APPEAL SUMMARY

Appeal ID: 21960	Project Address: 2211 SW 4th Ave
Hearing Date: 10/2/19	Appellant Name: Tom Jaleski
Case No.: B-019	Appellant Phone: 9712385266
Appeal Type: Building	Plans Examiner/Inspector: Gail Knoll, Corey Stanley
Project Type: commercial	Stories: 6 Occupancy: A-3, B, M, R-2, & S-2 Construction Type: Type III-A over Type I-A
Building/Business Name: SW 4th & Grant	Fire Sprinklers: Yes - Throughout
Appeal Involves: Erection of a new structure	LUR or Permit Application No.:
Plan Submitted Option: pdf [File 1] [File 2] [File 3] [File 4]	Proposed use: Residential, Mixed Use

Engineering Judgement Letter

SW 4th & Grant - EJ #1

Figure 1a: HSS Column Protection (Condition A)

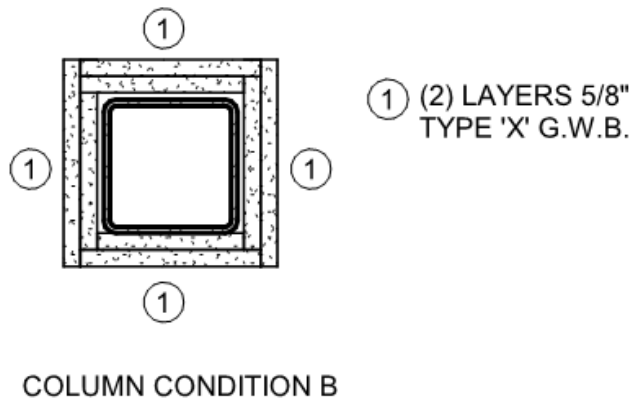
Fig. 1a

Column is to be protected with a combination of sacrificial studs and 5/8" Type X, GWB. Top and Bottom are protected with 1 hour of equivalent wood and 20 minutes of GWB over sacrificial blocking.

Location on Column	Protection Element	
Top and Bottom of detail	<ul style="list-style-type: none"> • (1) Layers of Type X gypsum board • (1) 2 x blocking 	<ul style="list-style-type: none"> • 20 mins for the bottom layer of 5/8" Type X gypsum board per NDS TR10 • 60 Minutes for 1.5" wood per OSSC <p>(Exceeds 60 Minutes)</p>
Left and Right side of detail	<ul style="list-style-type: none"> • (2) Layers of Type X gypsum board 	<ul style="list-style-type: none"> • 80 Minutes per CAM, OSSC • Exceeds UL design D759 (Fig 2 below)
Fire-Resistance Rating	Required (60 min minimum)	60 min (Exceeds minimum)

1. Alternate 1 hour fire rated HSS column assemblies with engineering analysis: Granted as proposed.

Figure 1b: HSS Column Protection (Condition B)

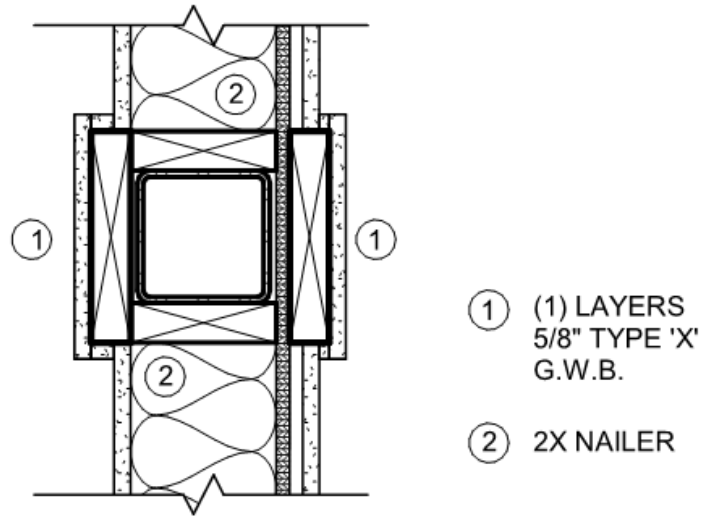
Fig. 1b

Column is to be protected with 2 layers of 5/8" Type X, GWB.

Location on Column	Protection Element	
Left and Right side of detail	<ul style="list-style-type: none"> • (2) Layers of Type X gypsum board 	<ul style="list-style-type: none"> • 80 Minutes per CAM, OSSC • Exceeds UL design D759 (Fig 2 below)
Fire-Resistance Rating	Required (60 min minimum)	60 min (Exceeds minimum)

Figure 1c: HSS Column Protection (Condition C)

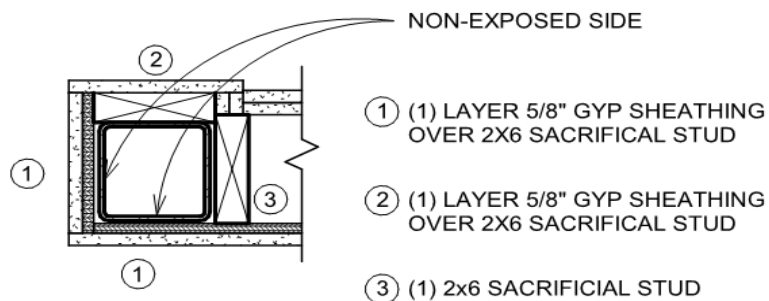
Fig. 1c

Column is to be protected with a combination of sacrificial studs and 5/8" Type X, GWB. Sides are protected with 1 hour of equivalent wood and 20 minutes of GWB over sacrificial blocking.

Location on Column	Protection Element	
Left and Right of detail	<ul style="list-style-type: none"> • (1) Layer of Type X gypsum board • (1) 2 x blocking 	<ul style="list-style-type: none"> • 20 mins for the bottom layer of 5/8" Type X gypsum board per NDS TR10 • 60 Minutes for 1.5" wood per OSSC (Exceeds 60 Minutes)
Top side of detail	(1) 2 x blocking (in stud cavity)	<ul style="list-style-type: none"> • 60 Minutes for 1.5" wood per OSSC
Fire-Resistance Rating	Required (60 min minimum)	60 min (Exceeds minimum)

Figure 1d: HSS Column Protection (Condition D)

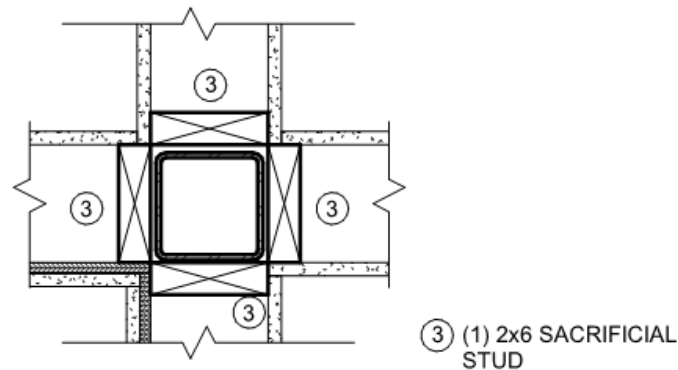
Fig. 1d

Column is to be protected with a combination of sacrificial studs and 5/8" Type X, GWB. Left and Bottom sides are not exposed to fire as the face exterior and Fire Separation distance is greater than 30 ft.

Location on Column	Protection Element	
Top and Right of detail	<ul style="list-style-type: none"> • (1) Layers of Type X gypsum board • (1) 2 x blocking (in stud cavity) 	<ul style="list-style-type: none"> • 60 Minutes for 1.5" wood per OSSC (60 Minutes)
Left and bottom side of detail	<ul style="list-style-type: none"> • Not rated 	<ul style="list-style-type: none"> • Per Table 602
Fire-Resistance Rating	Required (60 min minimum)	60 min (Meets minimum)

Figure 1a: Beam Protection (Condition A)

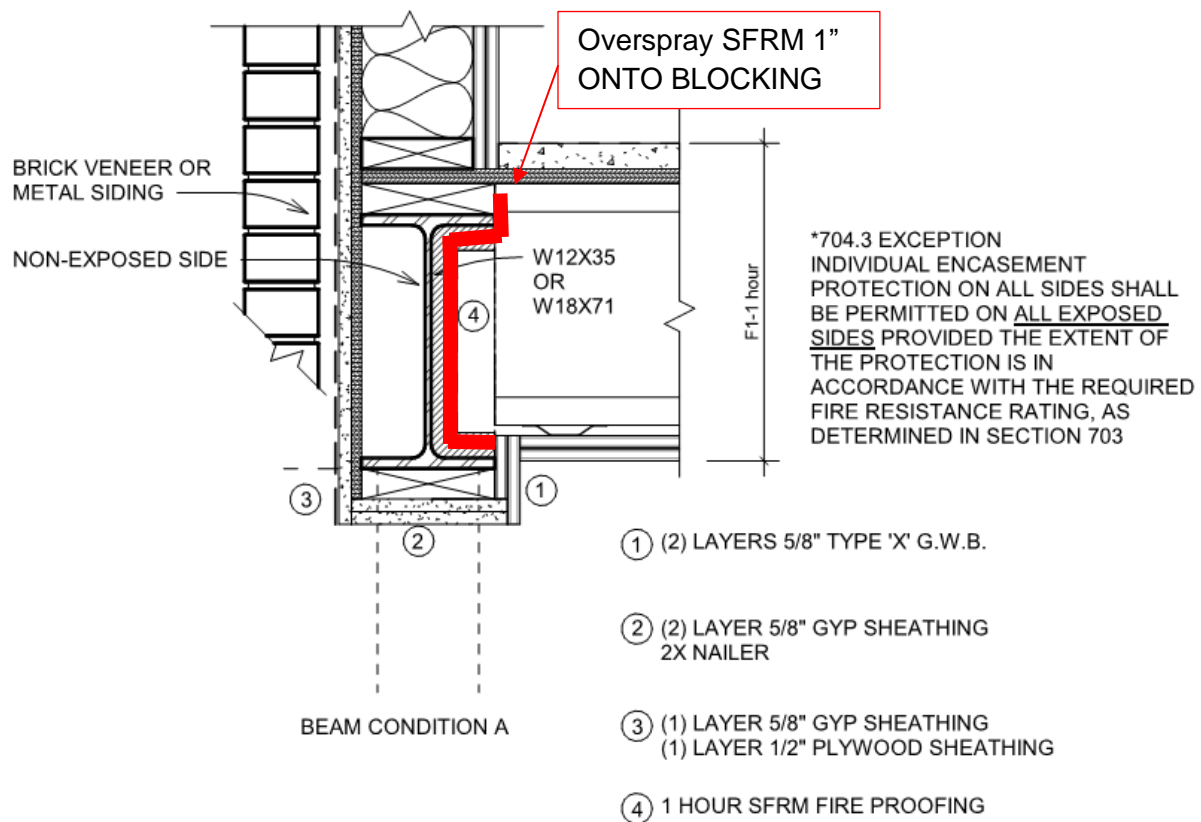
Proposed Design 1A(Fig. 1a)

Beam is to be protected with a combination of sacrificial studs and 5/8" Type X, GWB. Top and Bottom are protected with 1 hour of equivalent wood and 20 minutes of GWB over sacrificial blocking.

Location on Beam	Protection Element	
Bottom of detail	<ul style="list-style-type: none"> • (2) Layers of Type X gypsum board • (1) 2 x blocking 	<ul style="list-style-type: none"> • 60 mins for the 5/8" Type X gypsum board • 60 Minutes for 1.5" wood per OSSC <p>(Exceeds 60 Minutes)</p>
Right side of detail	<ul style="list-style-type: none"> • SFRM per S720 (9/16") 	<ul style="list-style-type: none"> • Meets UL design S720 (Fig 2 below)
Fire-Resistance Rating	Required (60 min minimum)	60 min (Exceeds minimum)

2. Alternate 1 hour fire rated beam assemblies with engineering analysis: Granted as proposed.

Figure 1b: Beam Protection (Condition B)

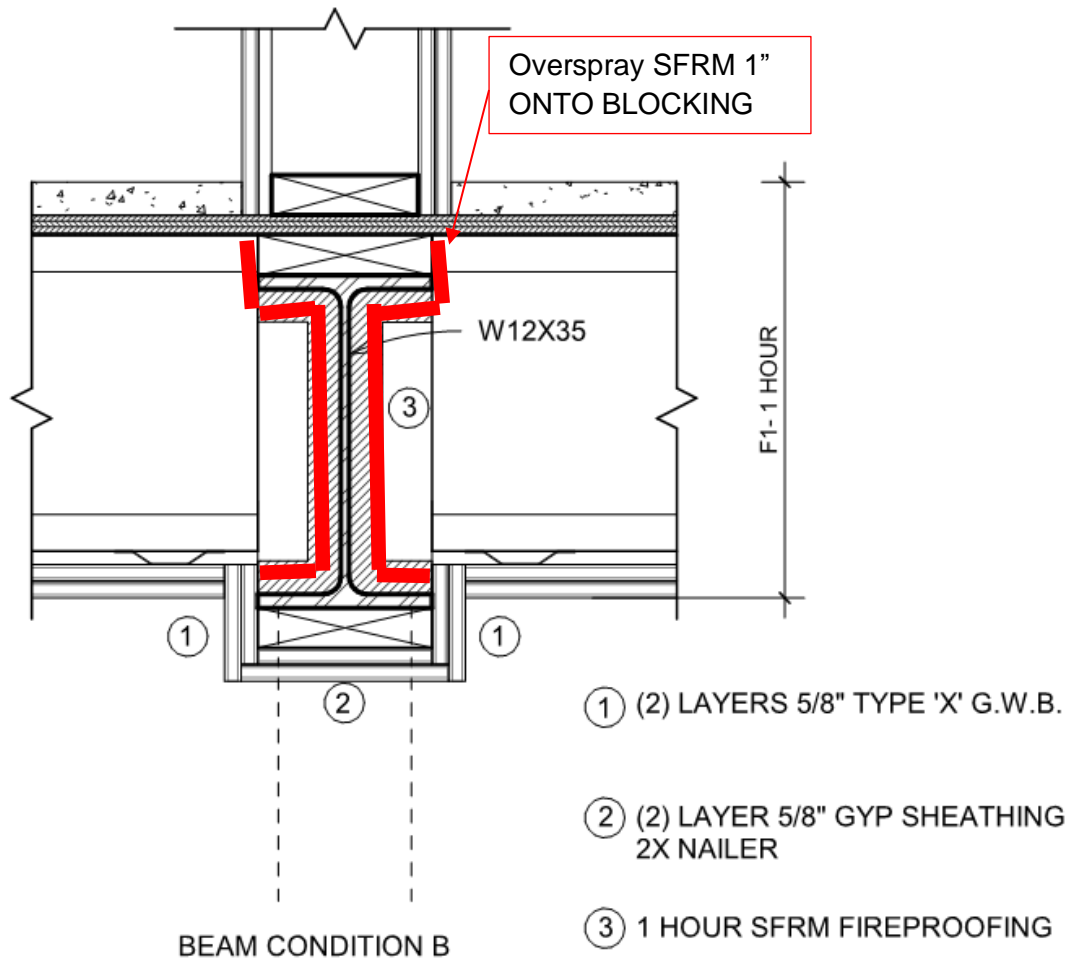
Proposed Design 1B (Fig. 1b)

Beam is to be enclosed in ceiling with 2 layers of 5/8" Type X GWB , Wood Blocking and SFRM.

Location on Beam	Protection Element	
Bottom of detail	<ul style="list-style-type: none"> • (2) Layers of Type X gypsum board • (1) 2 x blocking 	<ul style="list-style-type: none"> • 60 mins for the 5/8" Type X gypsum board • 60 Minutes for 1.5" wood per OSSC • (Exceeds 60 Minutes)
Left and Right side of detail	<ul style="list-style-type: none"> • SFRM per S720 (9/16") 	<ul style="list-style-type: none"> • Meets UL design S720 (Fig 2 below)
Fire-Resistance Rating	Required (60 min minimum)	60 min (Exceeds minimum)

Figure 1c: Beam Protection (Condition C)

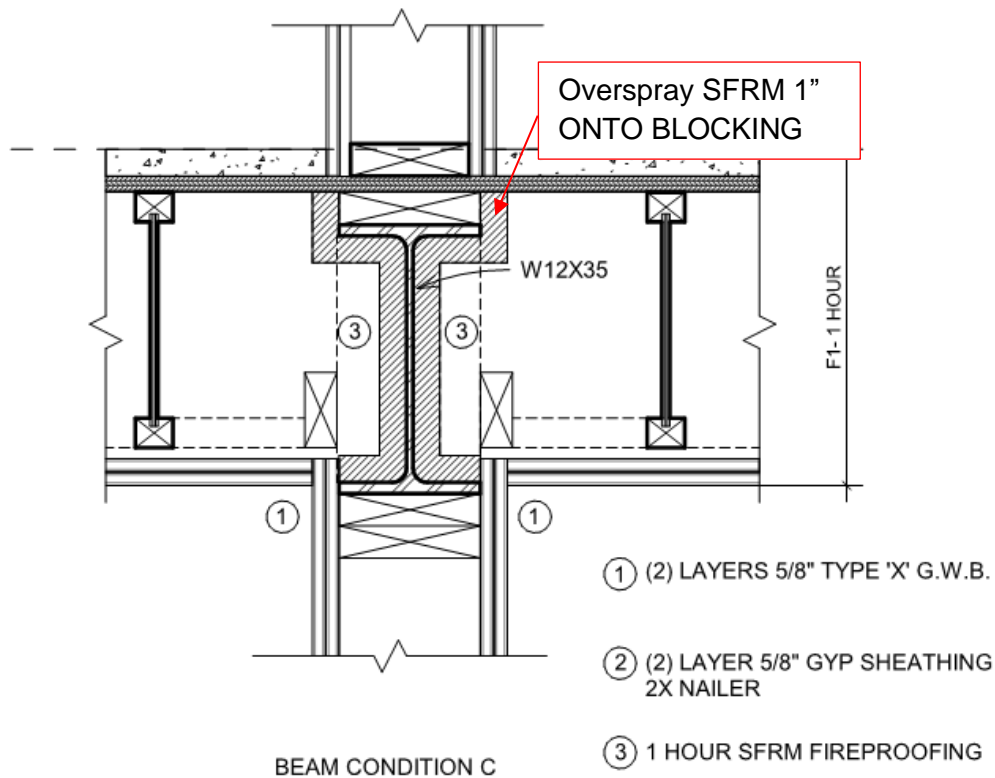
Proposed Design 1B (Fig. 1b)

Beam is to be enclosed in ceiling with 2 layers of 5/8" Type X GWB , Wood Blocking and SFRM.

Location on Beam	Protection Element	
Bottom of detail	<ul style="list-style-type: none"> • (2) Layers of Type X gypsum board • (2) 2 x blocking 	<ul style="list-style-type: none"> • 60 mins for the 5/8" Type X gypsum board • 120 Minutes for 1.5" wood per OSSC • (Exceeds 60 Minutes)
Left and Right side of detail	<ul style="list-style-type: none"> • SFRM per S720 (9/16") 	<ul style="list-style-type: none"> • Meets UL design S720 (Fig 2 below)
Fire-Resistance Rating	Required (60 min minimum)	60 min (Exceeds minimum)
